Intersection ID: 11754	Main Street: MECKLENBURG_AV	Cross Street: THURMOND_PL	Location:	SW
ADA ID: A02208712434	Ramp Type: PerpDiag	Initial Pass/Fail: Fail	Overall Compliance: No	Severity Score: 33.75

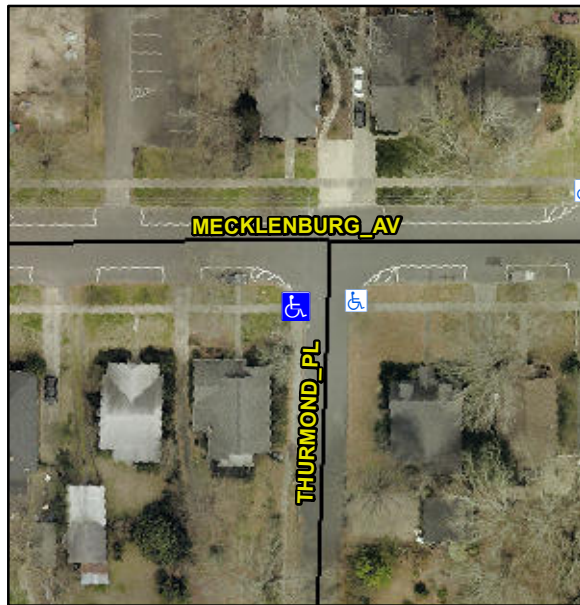
Not Found, R304.5.1, R304.2.2

Compliance	Description	Data	Compliance	Description	Data
N/A	Ramp Length (in)	62.0	No	Ramp Slope (%)	13.3
No	Ramp Width (in)	47.5	Yes	Ramp XSlope (%)	1.8
N/A	Flare Type LT	N/A	N/A	Flare Type RT	N/A
N/A	Flare Slope LT (%)	N/A	N/A	Flare Slope RT (%)	N/A
N/A	Flare Traversable LT?	N/A	N/A	Flare Traversable RT?	N/A
N/A	Landing Length (in)	N/A	N/A	DWS Provided?	N/A
N/A	Landing Width (in)	N/A	N/A	DWS Contrast?	N/A
N/A	Landing Slope (%)	N/A	N/A	DWS Length (in)	N/A
N/A	Landing X Slope (%)	N/A	N/A	DWS Full Width?	N/A
N/A	Landing Curb? (Y/N)	N/A	N/A	DWS Offset (in)	N/A
N/A	Shared Landing?	N/A			
N/A	Gutter Ponding?	N/A	N/A	Gutter Slope (%)	N/A
N/A	Gutter Lip Ht (in)	N/A	N/A	Gutter X Slope (%)	N/A
N/A	Painted X Walk1?	No	N/A	Painted X Walk2?	No
	X Walk 1 Direction	To E		X Walk 2 Direction	To N
N/A	X Walk 1 Width (in)	N/A	N/A	X Walk 2 Width (in)	N/A
	X Walk 1 Slope (%)	3.0		X Walk 2 Slope (%)	2.8
	X Walk 1 X Slope (%)	4.0		X Walk 2 X Slope (%)	3.1

Remove & Replace Curb Ramp With Two New Directional Ramps or Equivalent.
